**SUBDIVISION &
PLANNED UNIT DEVELOPMENT
STAFF REPORT**

Date: June 17, 2021

DEVELOPMENT NAME iSAM Addition to Bel Air Boulevard Subdivision,
Resubdivision of Lot 1

CONTEMPLATED USE Planned Unit Development Approval to amend a
previously approved Planned Unit Development to allow
shared access between two building sites; and Subdivision
approval to create two legal lots of record.

EXISTING SITE PLAN

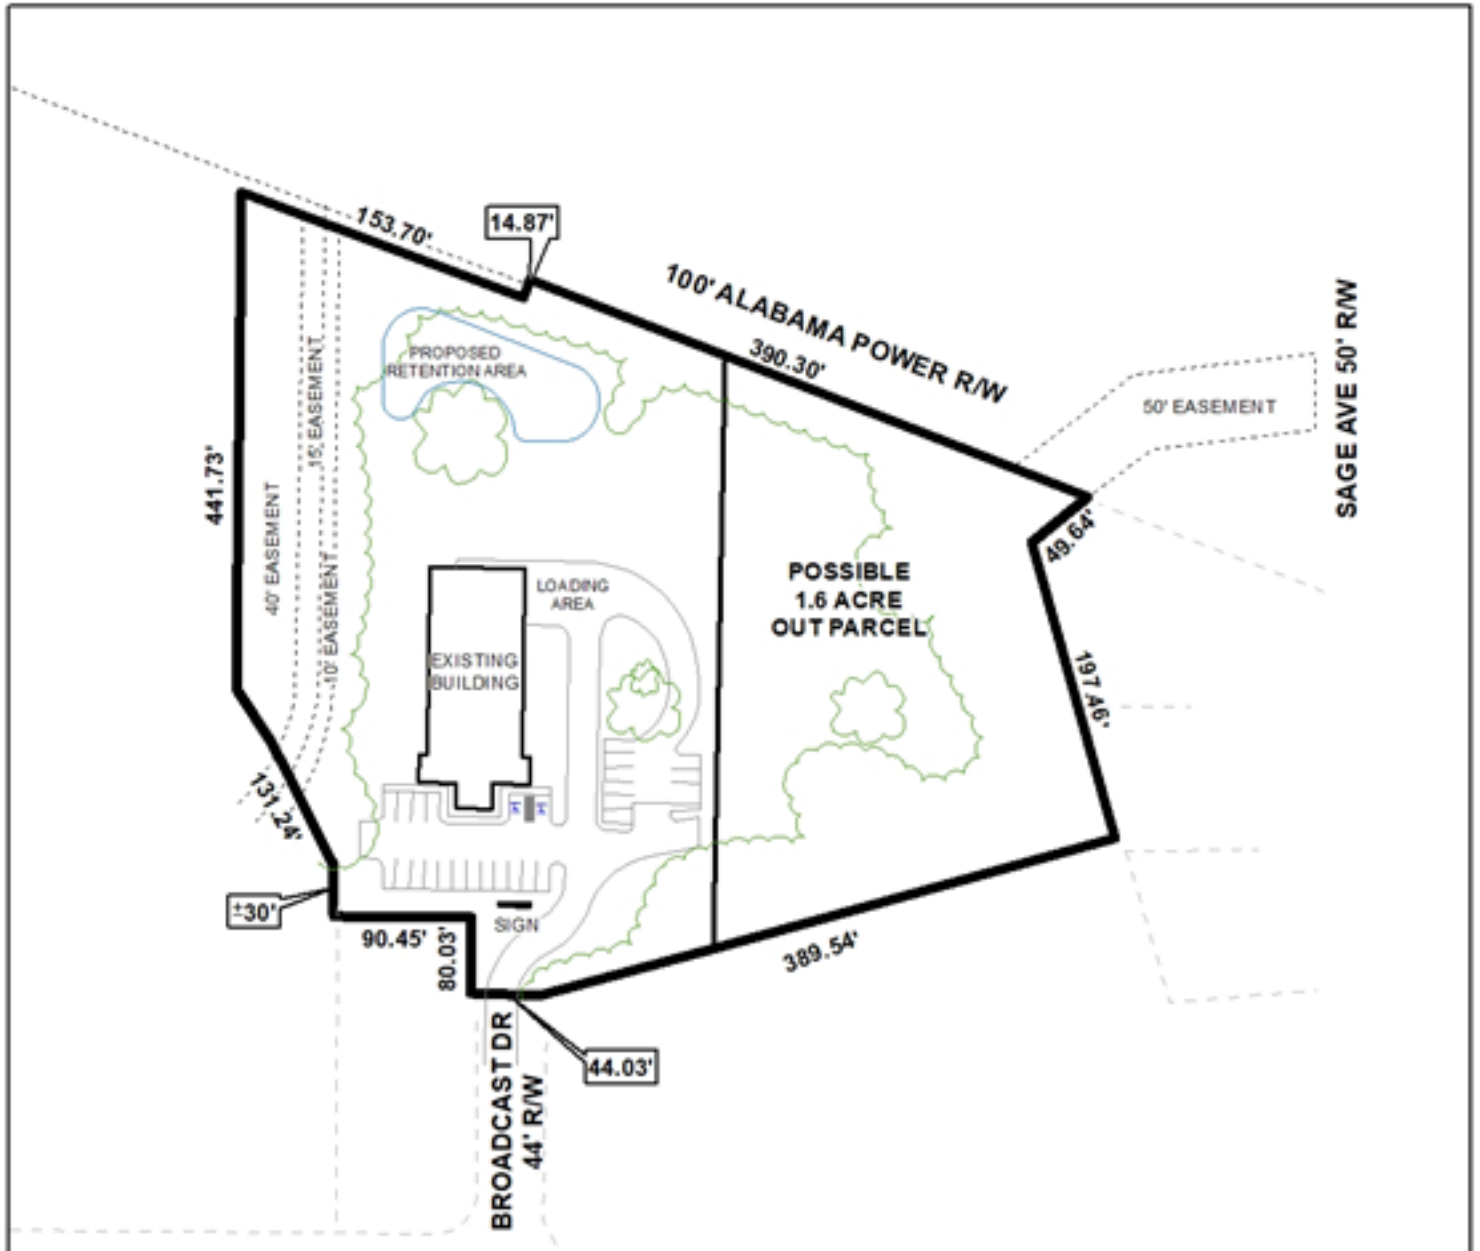
As you can see from the enclosed survey by McCrory-Williams Surveyors, we have an existing 50' non-exclusive access easement running from our property to Sage Avenue. According to that same survey (item #8), our current lot is "limited to the existing curb cut to Broadcast Drive, with the size, location, and design to be approved by Traffic Engineering and conform to AASHTO standards."

each of public street frontage. The applicant refers to Note # 8 *"This lot is limited to the existing curb cut Broadcast Drive, with the size, location and design to be approved by Traffic Engineering and conform to AASHTO standards"* on the recorded plat stating that the lot is limited to the existing curb cut to Broadcast Drive. In order to obtain sufficient street frontage to allow the creation of the proposed second lot, the inclusion of a recorded 50-foot non-exclusive access easement to Sage Avenue at the Northeast corner of the existing lot is proposed. As there was a PUD associated with the original subdivision for shared access onto Broadcast Drive, and as the proposed new lot would not utilize the Sage Avenue access, the PUD must be amended to allow the increased shared access onto Broadcast Drive. However, there are several aspects of the applications which are incomplete and must be addressed before an accurate review can be conducted.

No preliminary plat for the proposed two-lot subdivision was provided; therefore, a preliminary plat must be submitted. The 50-foot non-exclusive access easement must be made a part of the proposed second lot (real property frontage, not just an easement) in order for that lot to have its own required public street frontage. As the existing easement is across adjacent property owned by others (Lots 1 and 2, Eslava Creek Subdivision), those lots must also be included in the subdivision and PUD, with the owners of those lots authorizing their inclusion in both. It should be noted that with the reconfiguration of those two lots, it appears that Lot 1, Eslava Creek Subdivision would become land-locked if not further reconfigured to have adequate street frontage itself. Also, the Southeast corner of Lot 2, Eslava Creek Subdivision outside of the access easement is too small to be made a separate lot and would have to be incorporated into the proposed second lot of iSAM Addition to Bel Air Boulevard Subdivision, Resubdivision of Lot 1.

- 1) submittal of a preliminary plat for the proposed subdivision, to include adjacent lots which may need to be re-subdivided, as well as real property frontage on a street for the second lot;

PROPOSED SITE PLAN

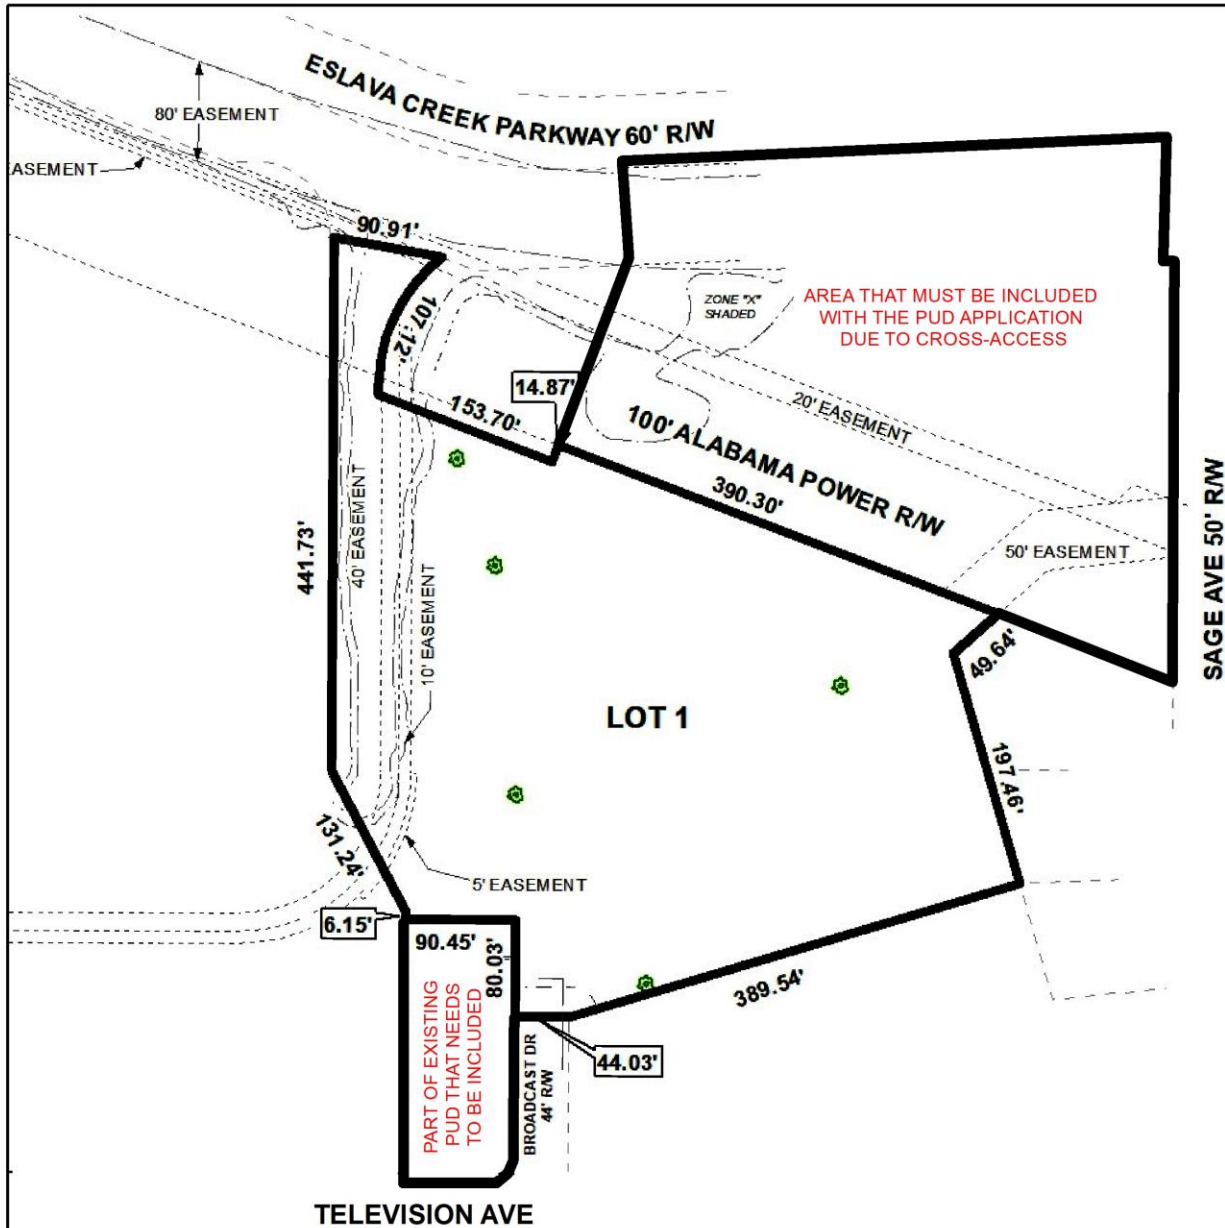
Basically, the applicant proposes to subdivide Lot 1, iSAM Addition to Bel Air Boulevard Subdivision into two lots. There is only one point at which the existing lot has at least the required minimum of 25 feet of public street frontage, and that is at the North terminus of Broadcast Drive. As the current frontage is only 44 feet, there is no further subdivision of that lot possible, as at least 50 feet of street frontage would be required to create two lots with 25 feet

Pertaining to the PUD, as the proposed two lots would not only share access with each other, but also with the property on the West side of Broadcast Drive which was included in the 2014 PUD, that property (Lot 1A, D.E.C. Subdivision, Resubdivision and Addition to Lot 1) must also be included in an amended PUD. The owners of that property must authorize its inclusion in the amended PUD.

- 1) submittal of a site plan to include the property on the West side of Broadcast Drive (Lot 1A, D.E.C. Subdivision, Resubdivision and Addition to Lot 1), which was included in the 2014 PUD, and inclusion of the properties to the North which are to be included in the subdivision;
- 2) revision of the mailing labels and fees to include any further property owners who may be within 300 feet of all boundaries of the PUD;and
- 3) authorization of inclusion into the PUD by the owners of Lot 1A, D.E.C. Subdivision, Resubdivision and Addition to Lot 1, and all owners of properties included in the subdivision.
